Ensuring that the CDB Fan Is Mounted Correctly

- Kodak Trendsetter® 400/800 III
- Kodak Trendsetter NEWS™ GMCE

Output devices affected All GMCE Trendsetters

The following photos show the correct mounting.

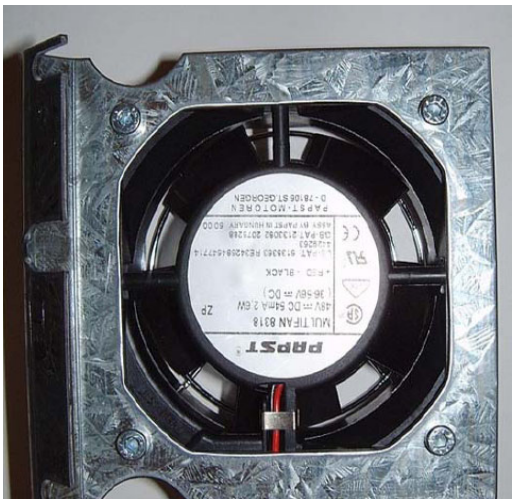
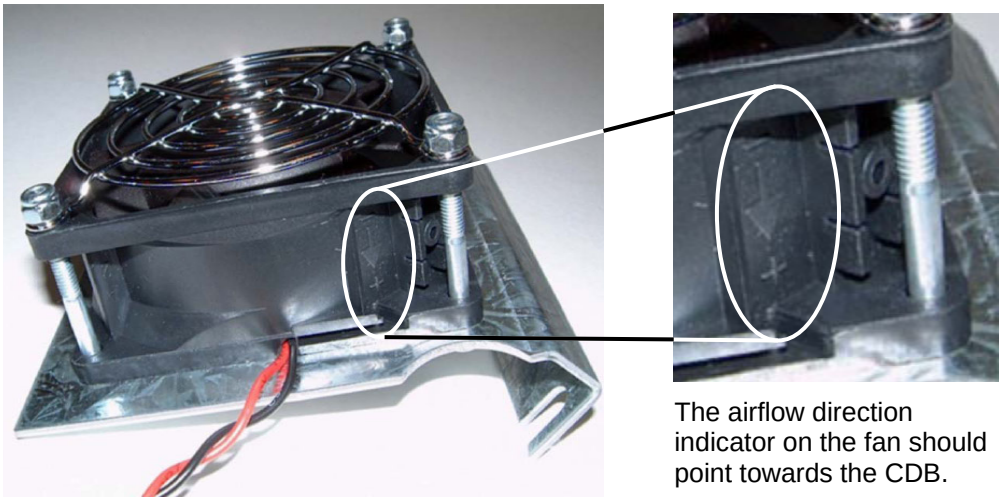
Some GMCE Trendsetter output devices have been shipped with the carriage driver board (CDB) cooling fan mounted facing the wrong way. The fan should blow air onto the board, not draw it away. Incorrect mounting of this fan can the carriage driver board to overheat.

The information label should face the CDB.

The airflow direction indicator on the fan should point towards the CDB.

4. If the fan is mounted incorrectly, undo the four nuts, turn the fan over, and reinstall the nuts.
   Note: Do not overtighten the nuts, because this may cause the fan housing to bend.
5. Close the power box and turn on the Trendsetter power.
